Waterway Analysis and Management System (WAMS)

U.S. Coast Guard Review of Sandy Hook Bay
including the Shrewsbury River
(1992 and 1999)

WATERWAY ANALYSIS AND MANAGEMENT SYSTEM

SANDY HOOK BAY

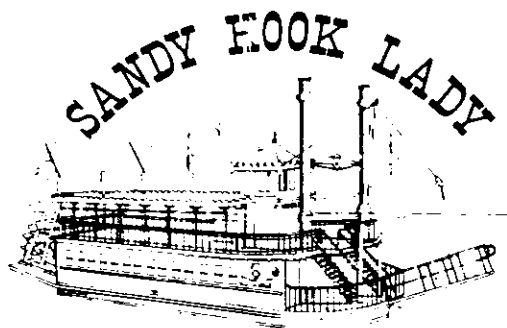
In our not-perfect world, what would help us more safely carry passengers through this hazardous area east of Oceanic Bridge, would be more buoys to mark the narrow channel, with its many "dog legs" and "S" turns; especially at "Borley Point." A #9 lighted buoy is greatly needed to aid navigation. #9 should be placed at the easterly point of land at Borley Point. Last year's buoy in this place somehow was removed, and this year is greatly missed.

Last year I could use the buoy and a street light on land behind it as a range, but this year I must navigate my 70-foot vessel through the strong current around Borley Point, hoping that my vessel does not set too far or too close to Borley Point, based on my memories of the area from last season.
